Addendum 4

RE: Addendum 4, ITB#20-01-013
Southeast Oconee Pressure Zone Water System Improvements

SOUTHEAST OCONEE
 PRESSURE ZONE
 WATER SYSTEM
 IMPROVEMENTS

EXHIBIT 1

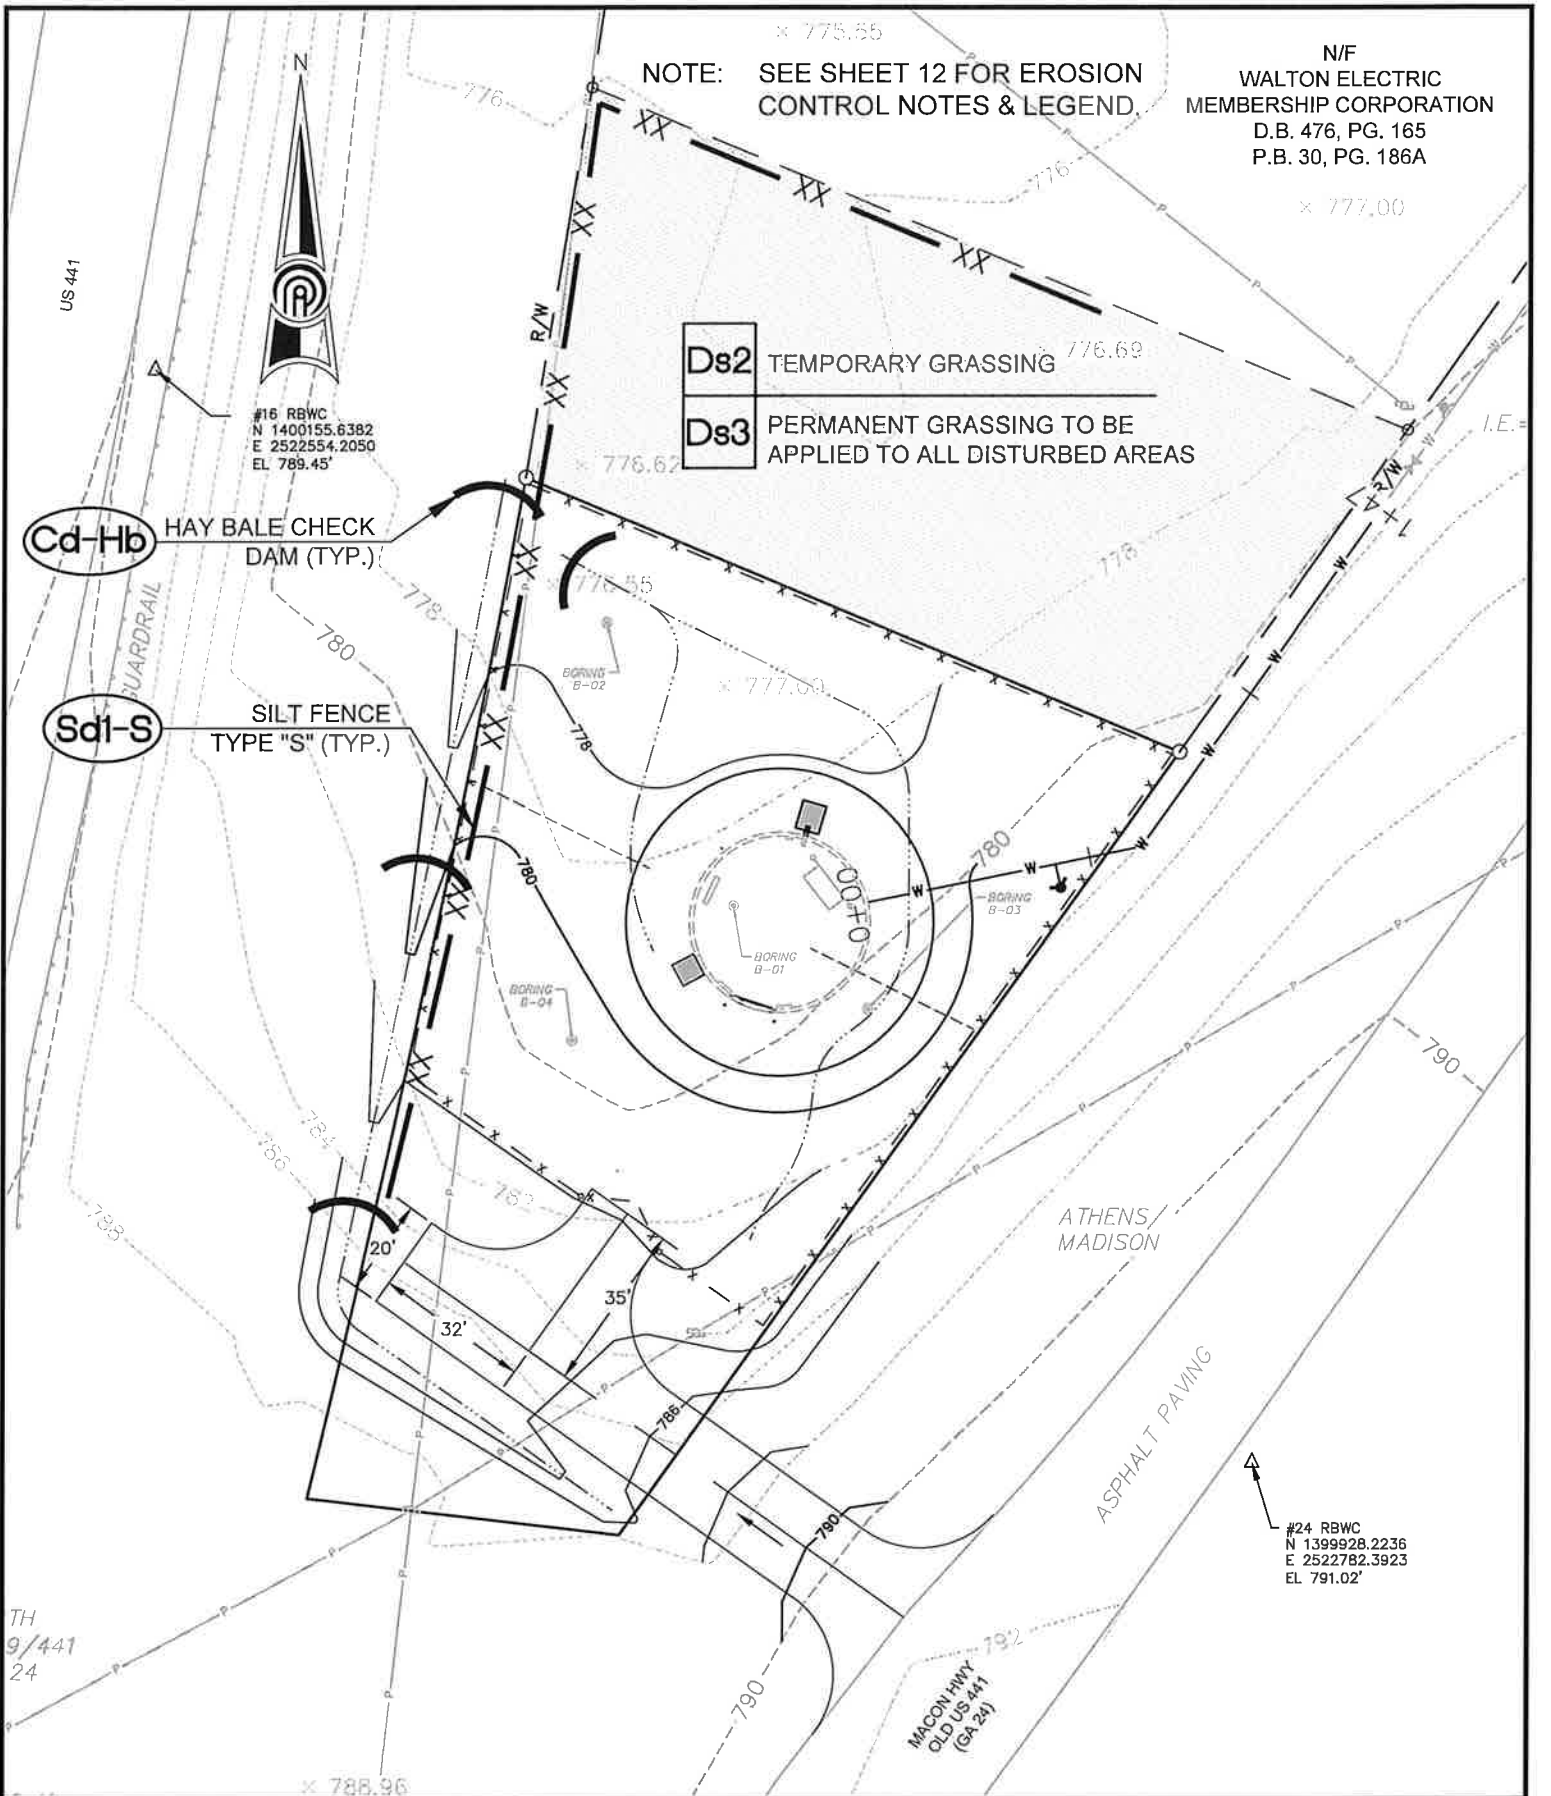
Sheet 4: Erosion control measures at the tank site shall be included as shown on the sketch included with this Addendum as Exhibit 1.
